Rezoning Transportation Analysis

Petition Number: 2023-011

Revision Log:	Date	Description
	5-24-23	First Review (TM)

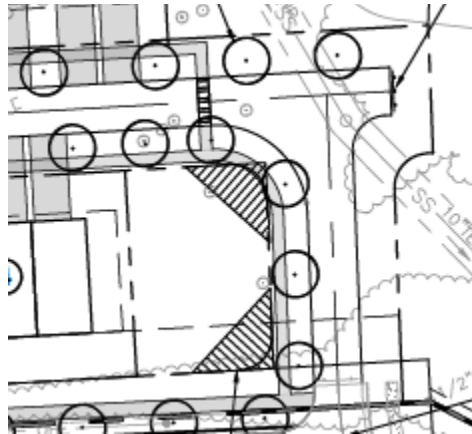
- a. **Citadel Place:** Location of curb and gutter to be moved to 13-feet from roadway centerline to accommodate the Charlotte Streets Map with a roadway typical section of Local Residential medium.

Label and dimension the curb and gutter from the centerline for each road on the site plan.

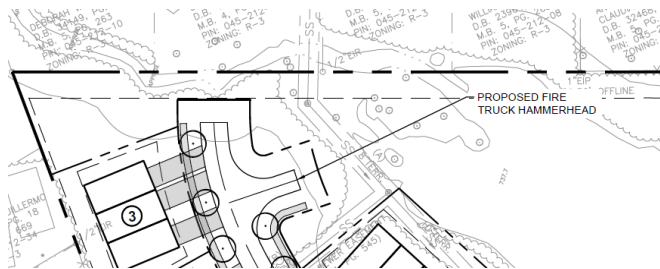
7. Revise site plan and conditional note(s) to commit to revising the proposed hammerhead to a cul de sac as to not stub to the single family homes to the North of the petition.
